AGENDA
PLANNING COMMISSION
116 WEST NEEDLES
BIXBY, OKLAHOMA
April 21, 2014 **6:00 PM**

**MINUTES
PLANNING COMMISSION
116 WEST NEEDLES
BIXBY, OKLAHOMA
March 17, 2014 6:00 PM**

'FINAL PLAT'
Wood Hollow Estates
A SUBDIVISION OF PART OF THE
S/2 OF GOVERNMENT LOT 4 OF SECTION 2, T-17-N, R-13-E
CITY OF BIXBY, TULSA COUNTY, OKLAHOMA
Planned Unit Development Number 80

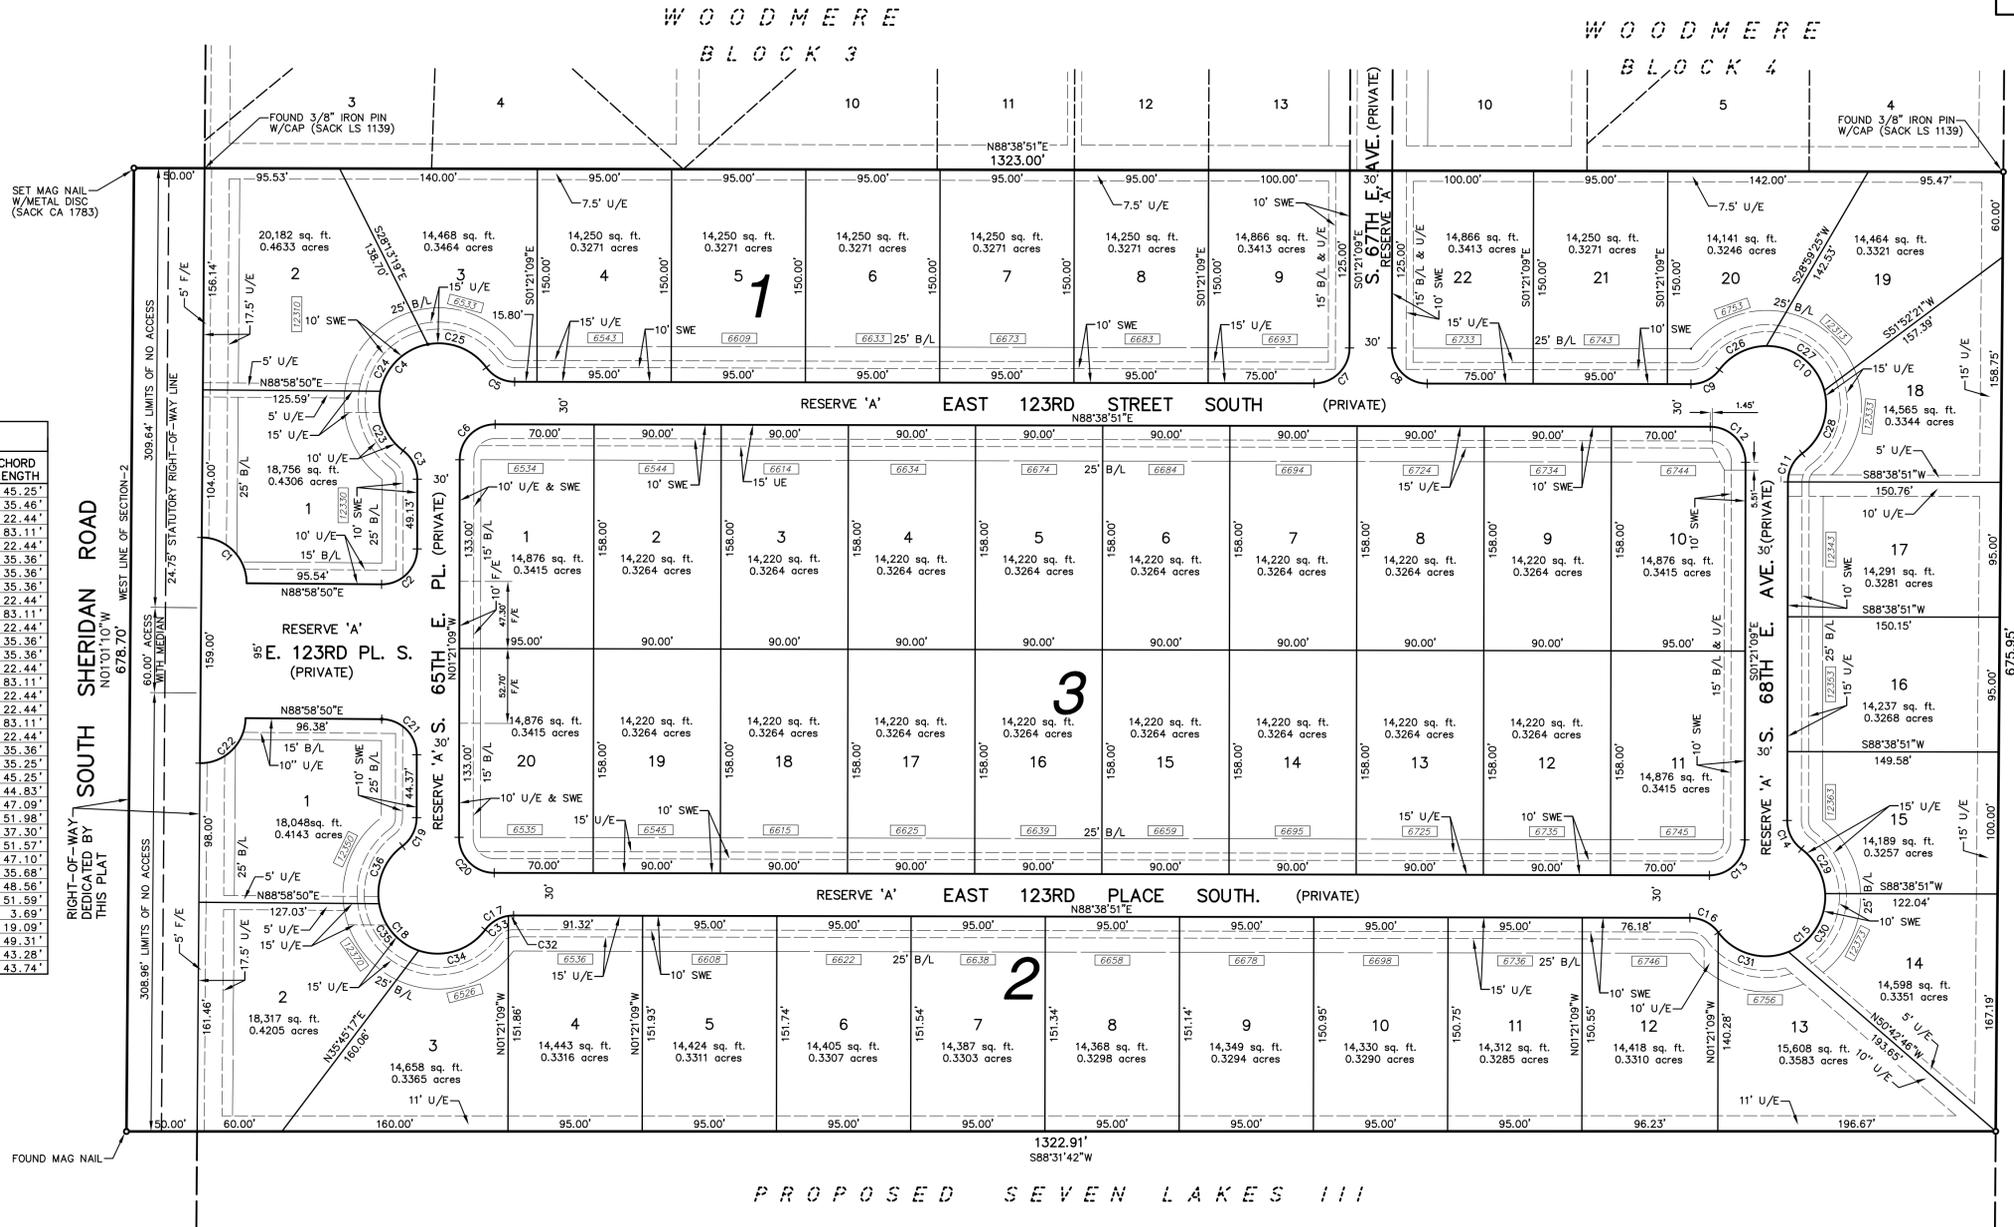
Erik, Welcome back and congratulations on your race in St. Louis. We met with Bea and Jared yesterday and came to an agreement on the easement widths - 7.5' on the north, 15' on the east, and 11' on the south. With this agreement we would like to ask the City Council to reconsider their motion and approve the final plat with the easements as agreed too.

Staff Recommendation. For all the reasons outlined above, Staff can support the amended request for Modification/Waiver as follows: 7.5' on the north, 15' on the east, 11' on the south, and (as has been proposed all along) 17.5' on the west.
